Access Compliance Report

Public Rights-of-Way

Intersection ID: 23415	Main Street: ENGLISH_MEADOWS_LN	Cross Street: OLD_PROVIDENCE_RD	Location: NE
ADA ID: 97E485A0F042	Ramp Type: PerpDiag	Initial Pass/Fail: Fail	Overall Compliance: No
Severity Score: 12.5			
Codes/Mitigation Info/Possible Solution		Field Measurements/Component Compliance

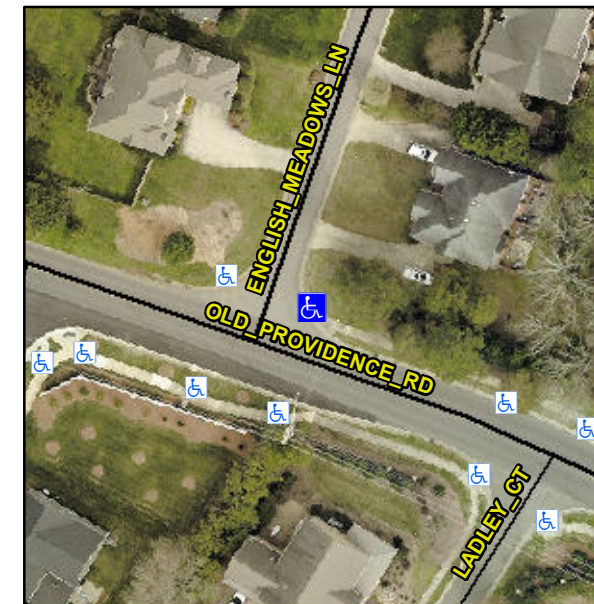
Not Found, R304.2.2

Compliance	Description	Data	Compliance	Description	Data
N/A	Ramp Length (in)	59.0	No	Ramp Slope (%)	10.7
Yes	Ramp Width (in)	48.0	Yes	Ramp XSlope (%)	0.4
N/A	Flare Type LT	N/A	N/A	Flare Type RT	N/A
N/A	Flare Slope LT (%)	N/A	N/A	Flare Slope RT (%)	N/A
N/A	Flare Traversable LT?	N/A	N/A	Flare Traversable RT?	N/A
N/A	Landing Length (in)	N/A	N/A	DWS Provided?	N/A
N/A	Landing Width (in)	N/A	N/A	DWS Contrast?	N/A
N/A	Landing Slope (%)	N/A	N/A	DWS Length (in)	N/A
N/A	Landing X Slope (%)	N/A	N/A	DWS Full Width?	N/A
N/A	Landing Curb? (Y/N)	N/A	N/A	DWS Offset (in)	N/A
N/A	Shared Landing?	N/A			
N/A	Gutter Ponding?	N/A	N/A	Gutter Slope (%)	N/A
N/A	Gutter Lip Ht (in)	N/A	N/A	Gutter X Slope (%)	N/A
N/A	Painted X Walk1?	No	N/A	Painted X Walk2?	No
	X Walk 1 Direction	To NW		X Walk 2 Direction	To S
N/A	X Walk 1 Width (in)	N/A	N/A	X Walk 2 Width (in)	N/A
	X Walk 1 Slope (%)	0.5		X Walk 2 Slope (%)	0.7
	X Walk 1 X Slope (%)	0.7		X Walk 2 X Slope (%)	1.8

Remove & Replace Curb Ramp With Two New Directional Ramps or Equivalent.
